AMENDMENTS TO THE DRAWINGS

Attached hereto is(are) four (4) sheet(s) of corrected formal drawings that comply with the provisions of 37 C.F.R. § 1.84. The corrected formal drawings incorporate the following drawing changes:

Fig. 1

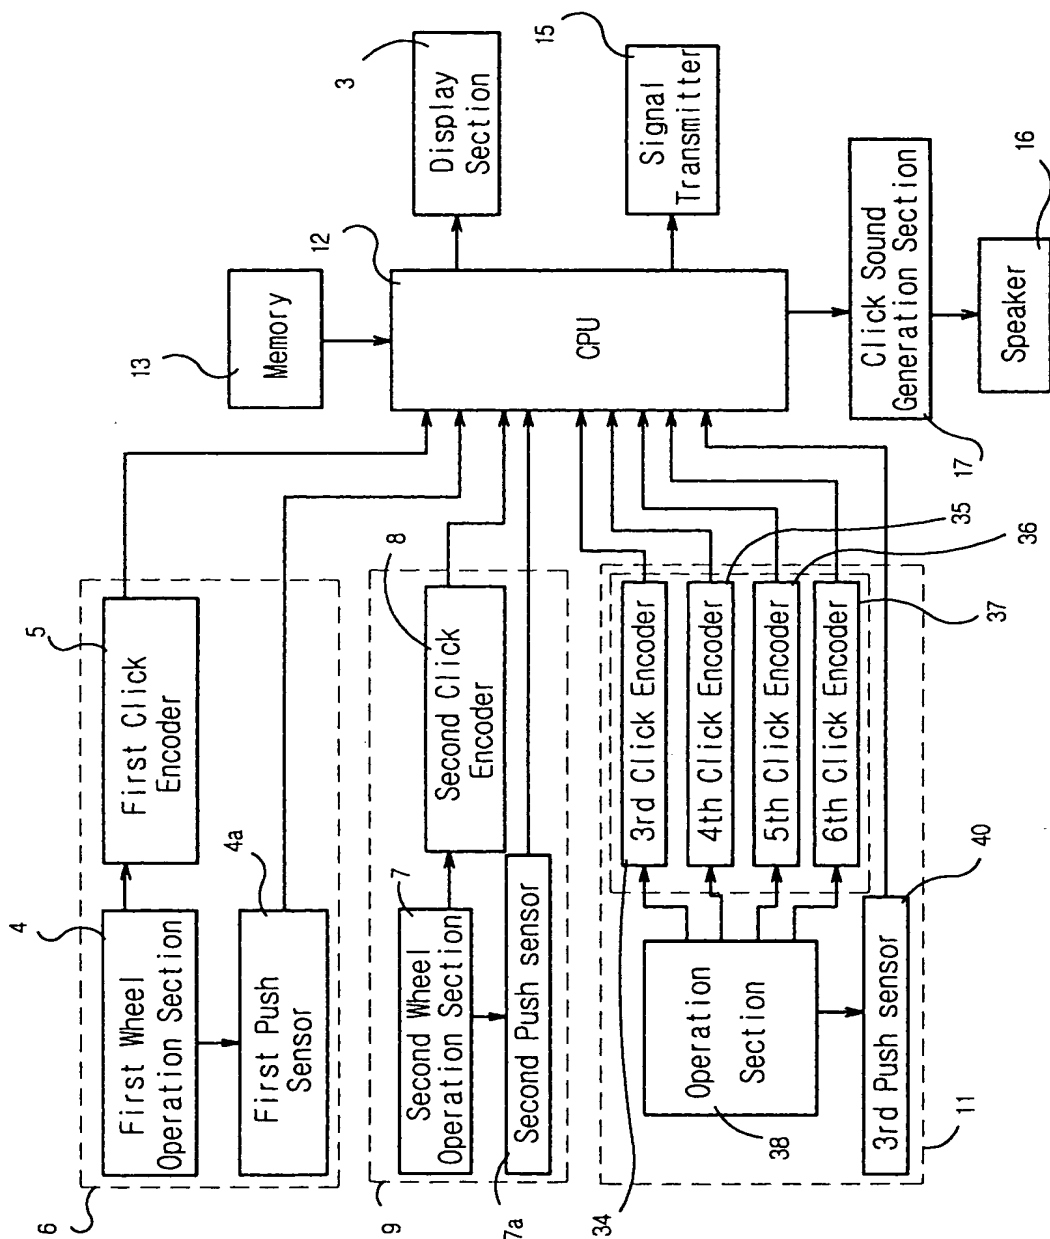
Figures 1, 6, 7, and 8 are amended as follows. In Figure 1, the boxes represented by reference numerals 4, 4a, 5, 7, 8, 34-37 and 40 are amended to read as follows: first wheel operation section; first push sensor, first click encoder, second wheel operation section, second push sensor, second click encoder, third click encoder, fourth click encoder, fifth click encoder, sixth click encoder, and third push sensor.

Fig. 6

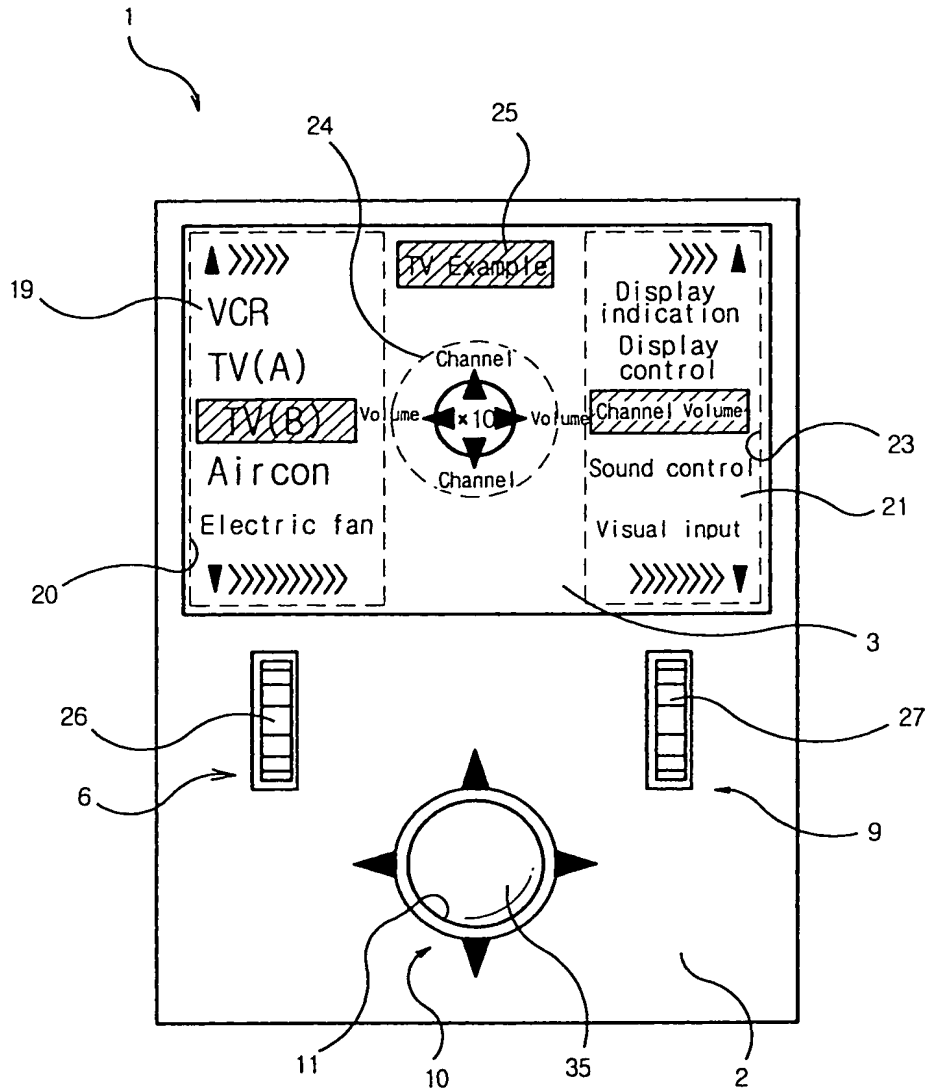
In Figures 6 and 7, the icon spelled "Chanel Volume" is replaced by "Channel Volume."
